**PRE-BID ADDENDUM****Cuba Township Office Renovation****28000 W Cuba Rd, Barrington, Illinois - 60010**

APA PROJECT #	25-023	DATE ISSUED	10-7-26
ADDENDUM NO.	001	BID DUE	10-7-26
OWNER	Cuba Township	ISSUED BY	APA

SMC		SOIL AND MATERIAL CONSULTANTS, INC.	LOCATION SKETCH
Client:	CUBA TOWNSHIP		
Project:	28000 W. CUBA ROAD		
Location:	BARRINGTON, ILLINOIS		
File No.	29166	Date: 12-23-25	Scale: 1" ≈ 20'

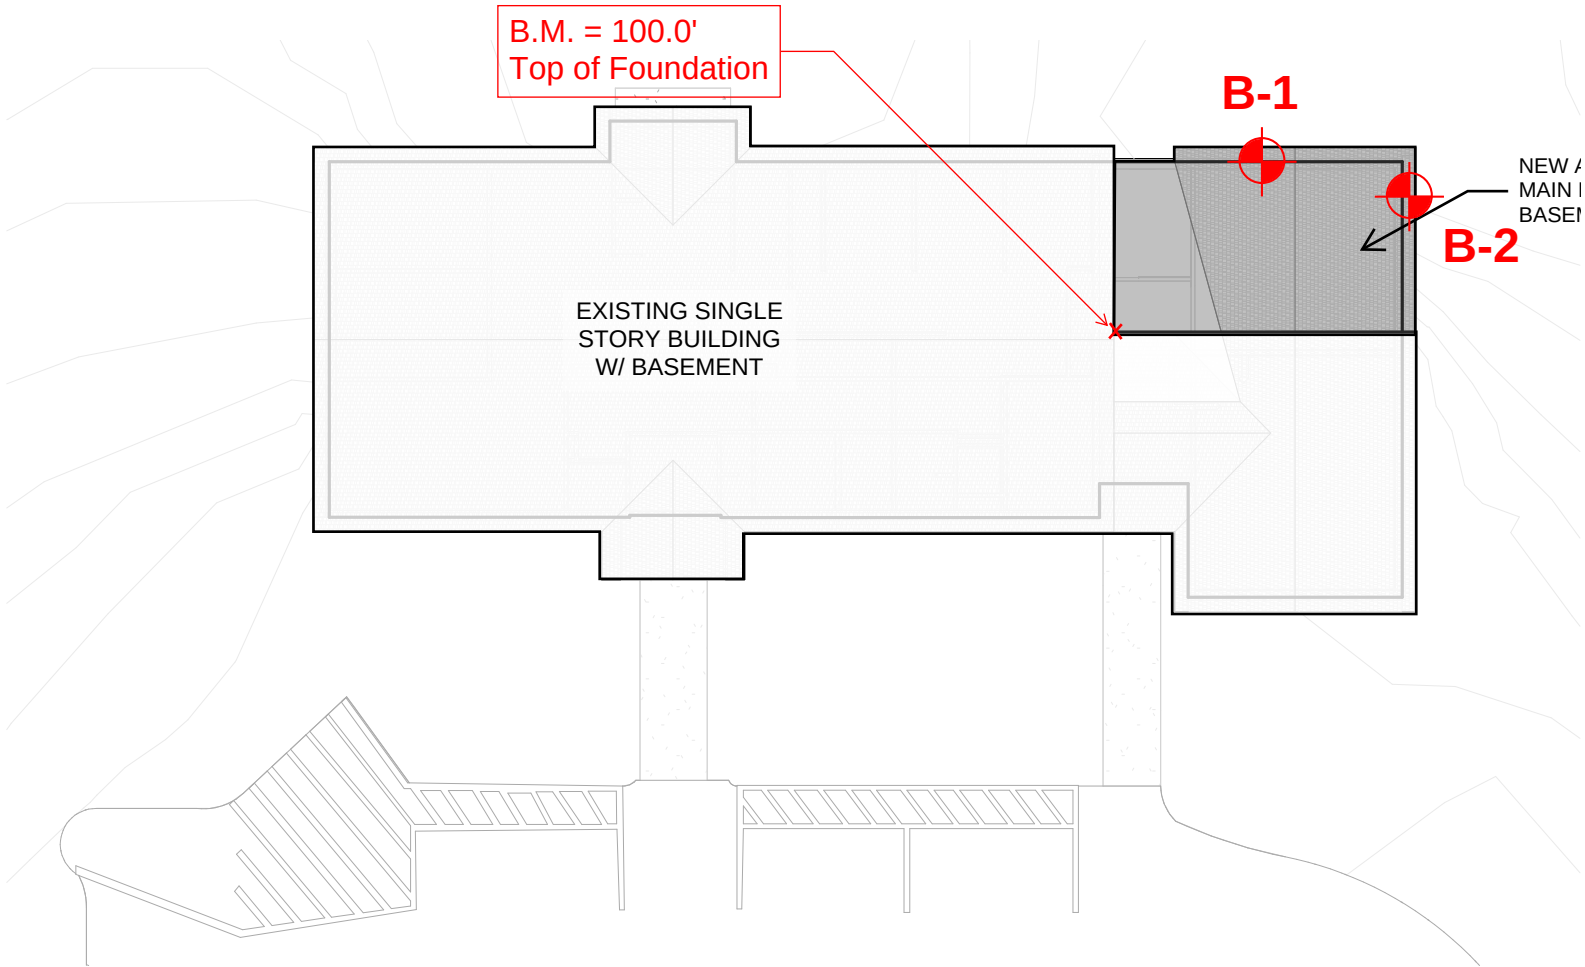
Question 6 : Please provide soils report.

Answer 6 : Please find the report attached here.

1 FINISH PLAN
SCALE: 1/8"=1'-0"

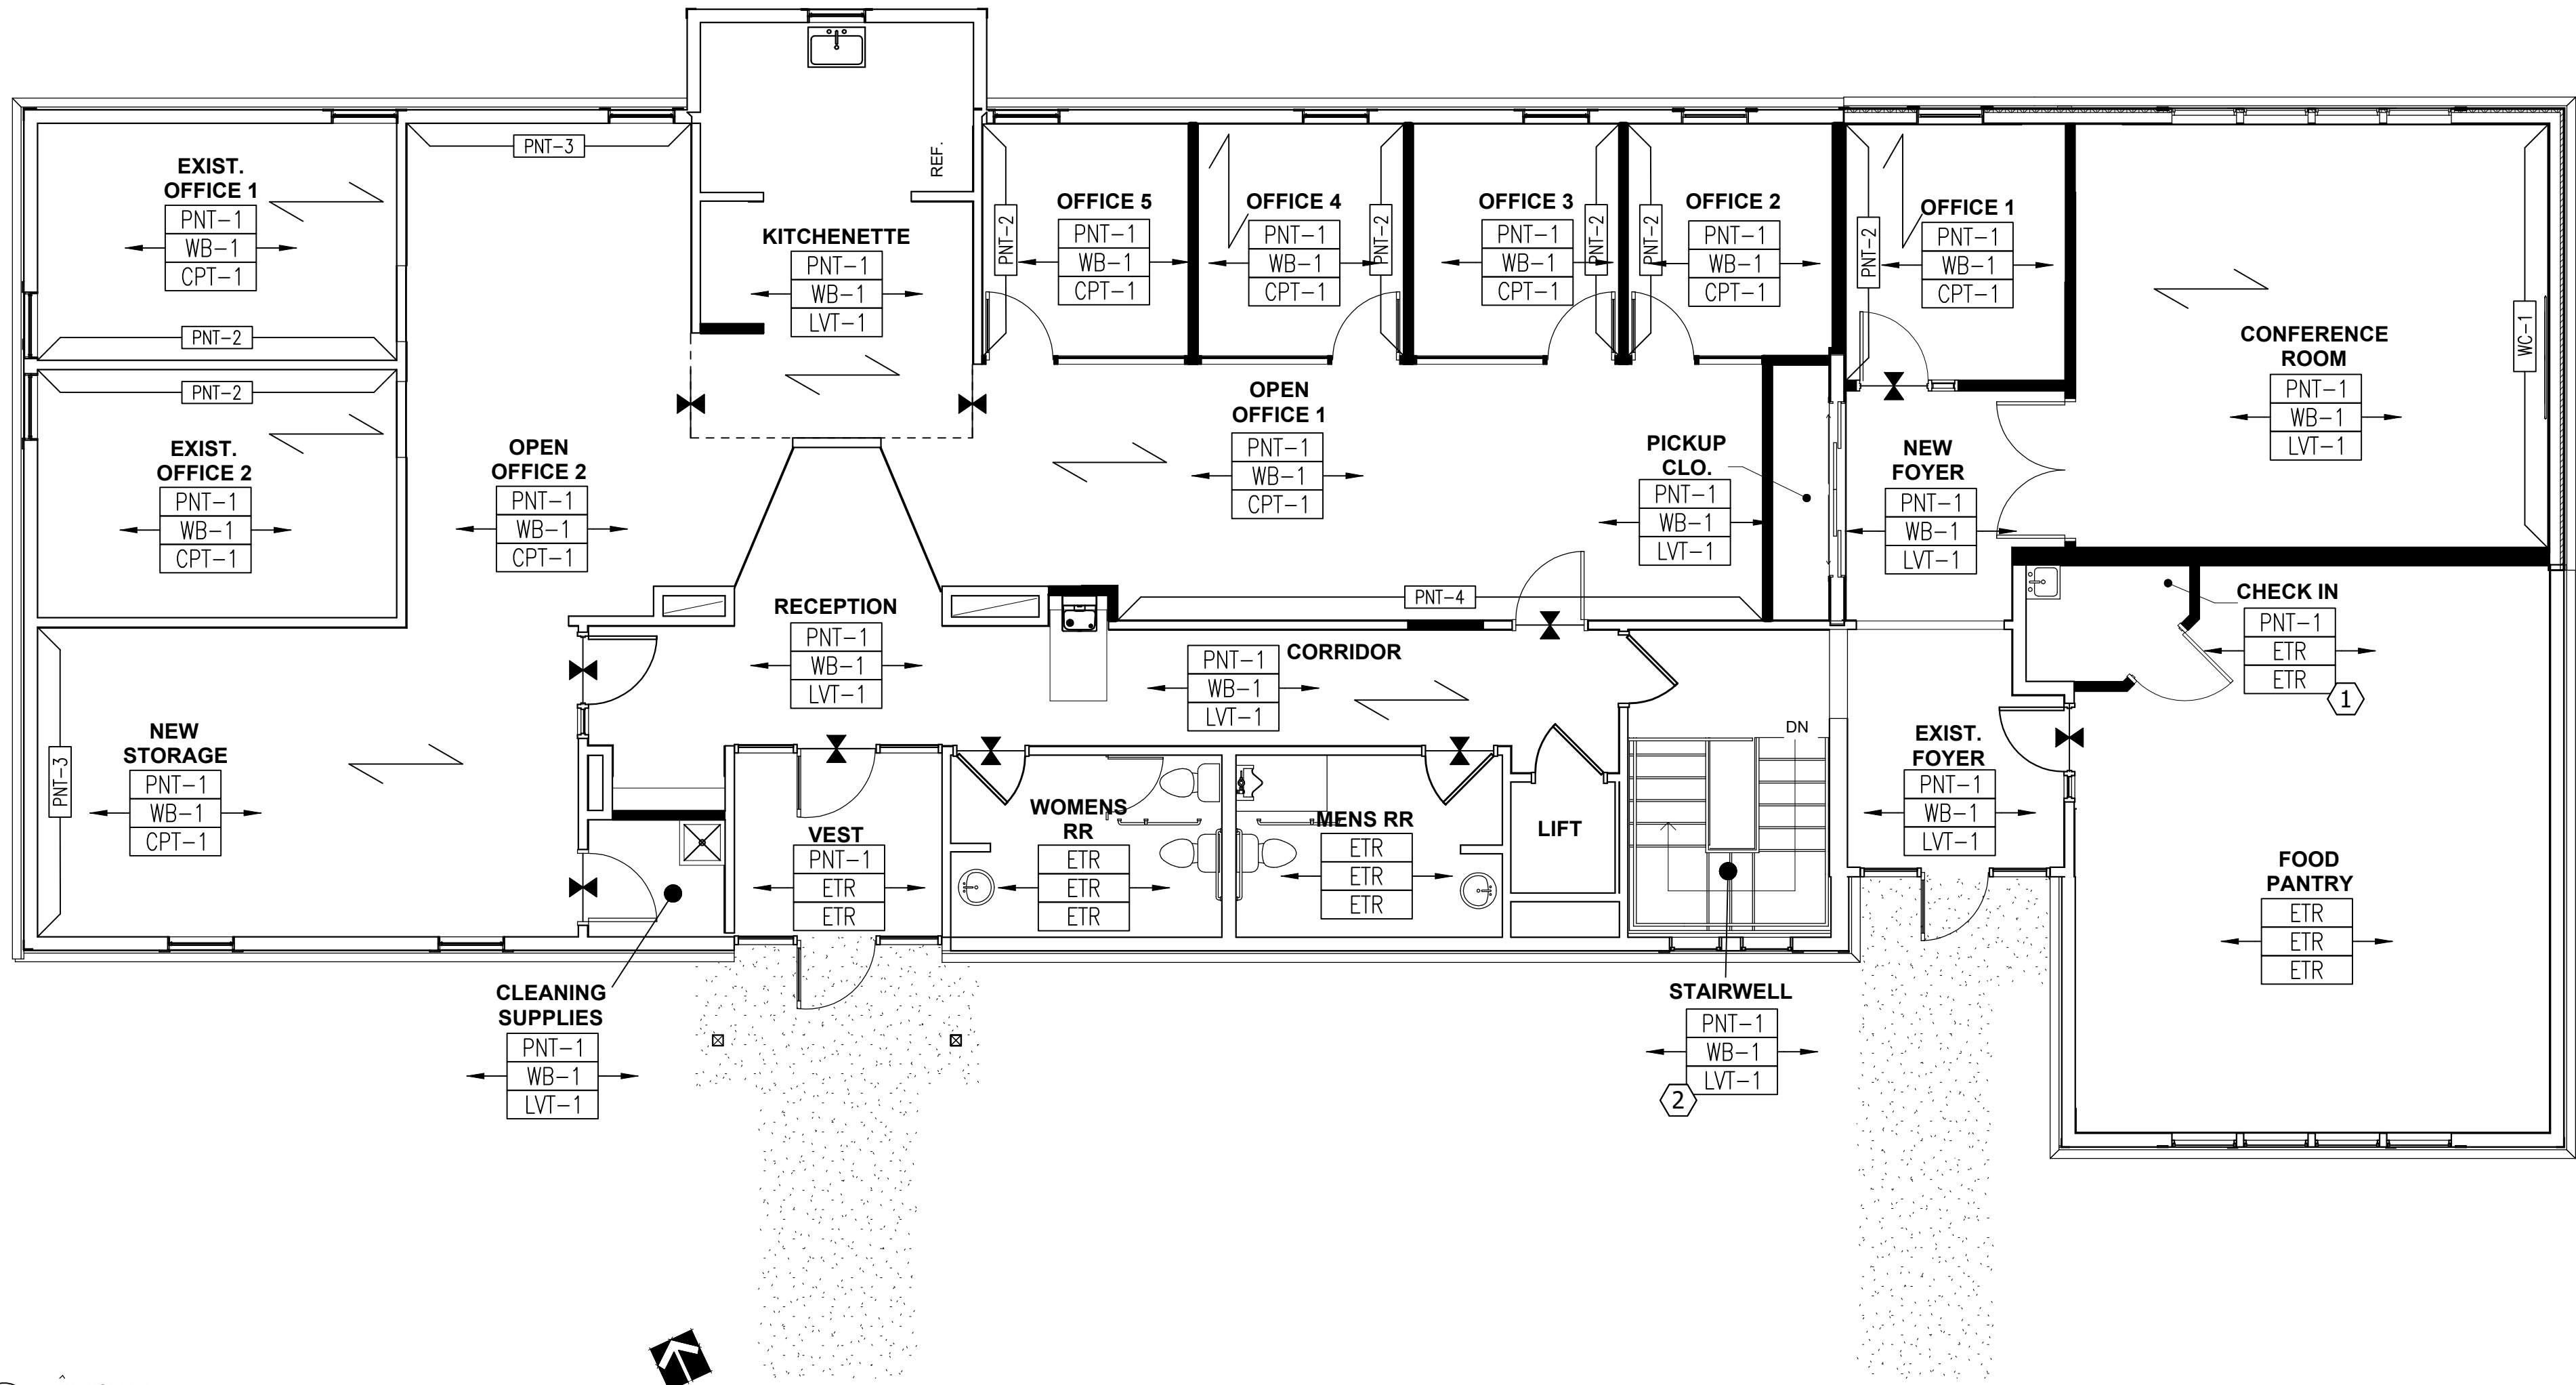
Question 11 : Please provide room finish schedule and confirm existing flooring material to be patched at demoed walls/cabinets in existing building.

Answer 11 : Please see the attached room finish plan. Yes, existing materials must be repaired/patched at demoed walls/cabinets.
